# DEVELOPMENT PLAN—PARCEL 3

Above: Proposed section and new Exhibit H showing the colonnade adjacent to South Street and the cantilevered parking garage concept.

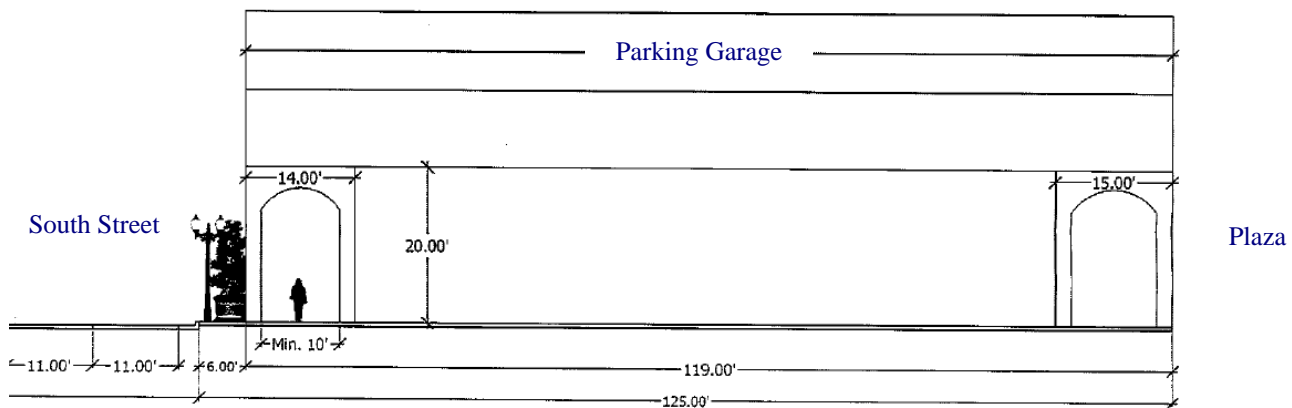
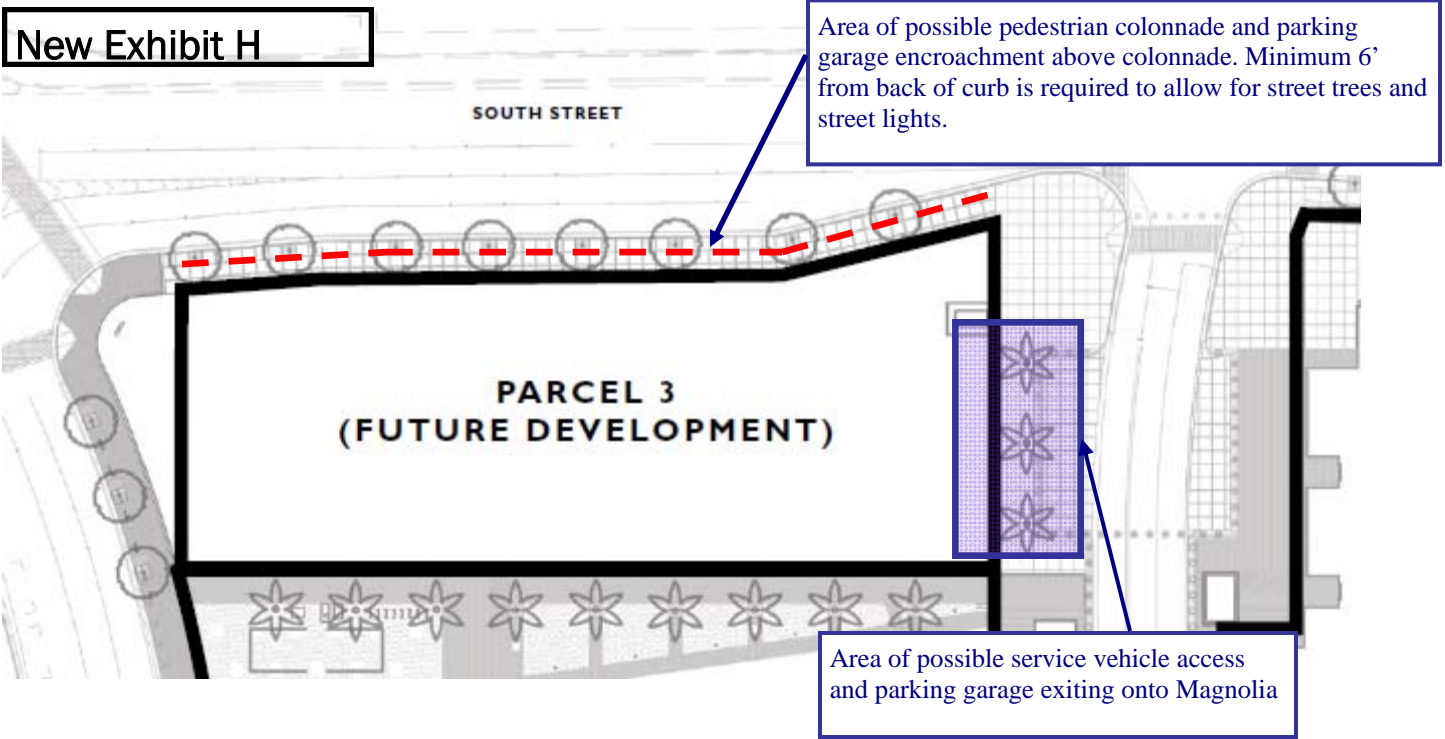
Below: Parcel 3 proposed diagram of encroachment into South Street ROW for Colonnade. A SPMP is still required for Parcel 3, however, South Street was realigned adding an additional lane, which affected the ROW for Parcel 3. In order to fit a feasible parking garage on the site and still meet the existing conditions of the PD, a study was conducted of the possible streetscape as a colonnade and a parking podium encroaching over the ROW as shown.

Also due to the realignment of South Street, the access to the future building on Parcel 3 has been considered. This Amendment is adding language to Section 6: Conditions Specific to Parcel 3, Section 3.1, to allow access to Magnolia in a limited manner, for service vehicles and exiting the parking garage. Final SPMP is still required, and the current PD limits all access to South Street. Access on the east side of the property is sensitive, as the service area would be across the street from the DPAC front façade and entrance. Additional design standards have been provided, as well as careful consideration to the pedestrian zones and streetscape treatment adjacent to Magnolia. Existing street trees, lighting, and pavement treatment shall carefully be considered when Parcel 3 is developed in order to have the least impact on the existing streetscape and pedestrian zones.
